Stubenburg After-The-Fact

APPLICATION FOR SHORELINE SETBACK VARIANCE

FINAL ENVIRONMENTAL ASSESSMENT

Existing Shoreline Revetment, Wood Fence and Walkway

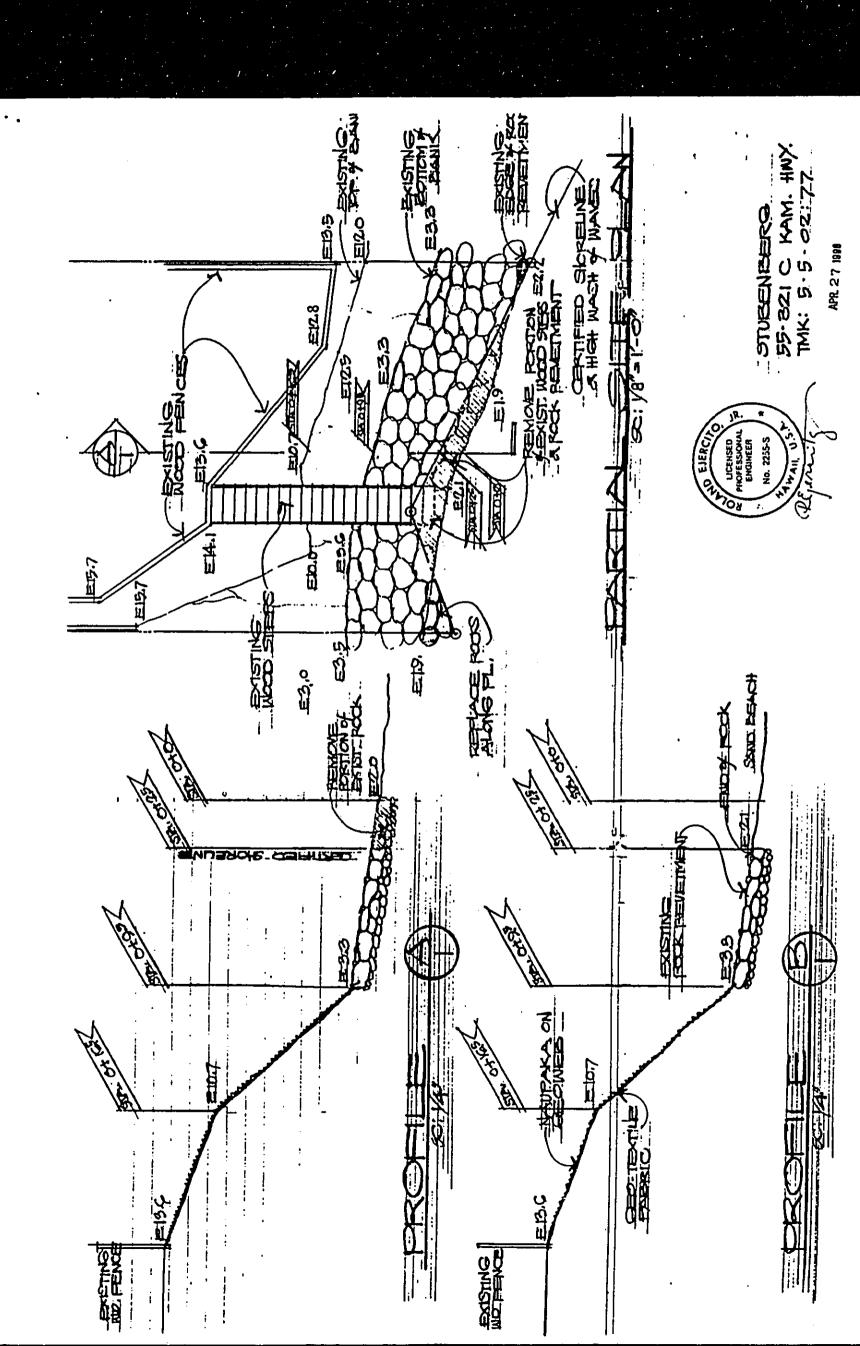
Attached is a copy of the plan showing encroachment of the existing reventment and wood walkway.

Please instruct Mr. Joe Correa to remove the portion of the existing revetment and wood walkway.

EXHIBIT B

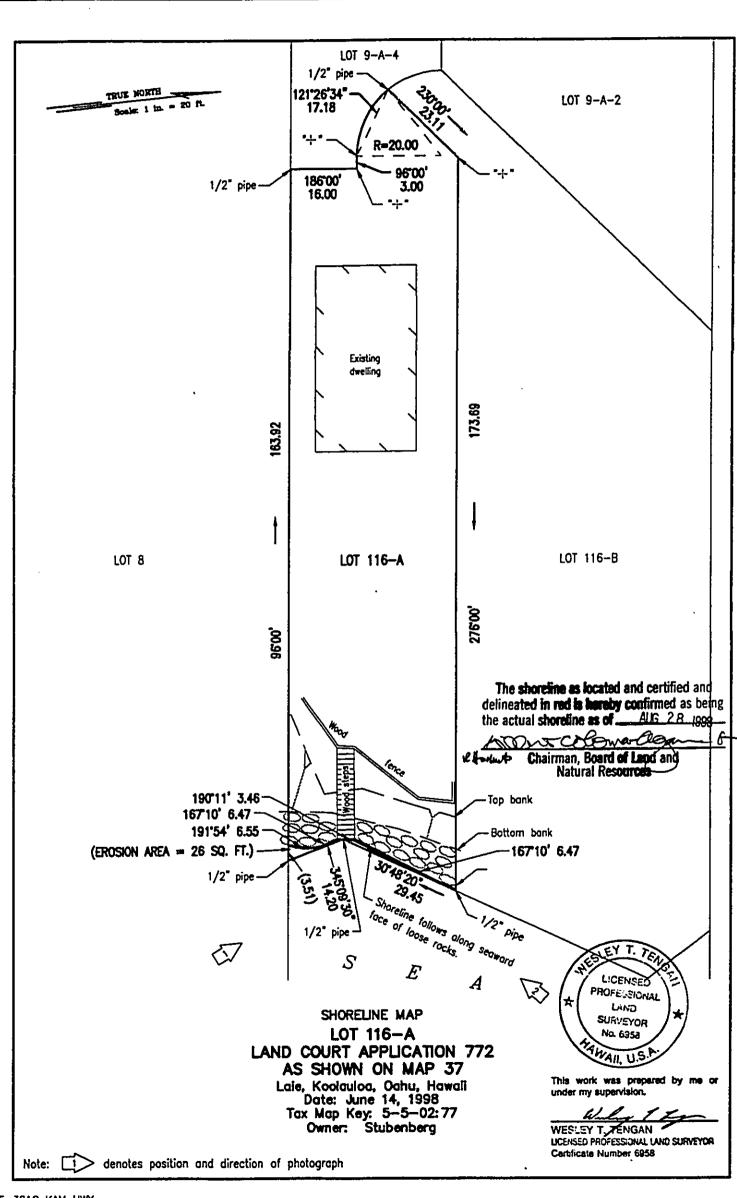
Exhibit shows a blanket of geo-textile fabric along Profile B-1, however B-1 is not marked in the Plan View, and use of geo-textiles is not mentioned in the text.

Similarly, Exhibit 6, Typical Beach Profile, also fails to illustrate this significant shoreline feature. This exhibit should be redrawn with a useful scale, both horizontal and vertical. Also, a vertical scale should be provided for Exhibit B (the engineer stamped plans of the revetment).

8. Structure Description: Although this section mentions a grout cap on the existing revetment which was not damaged during the storm surf of November 1996, this feature is not described or shown elsewhere in the Draft EA (including on the engineer stamped plans, "Exhibit B"). The Final EA should clarify this matter.

All maps and plans included in the FINAL EA will show a useful scale or otherwise indicated as NTS.
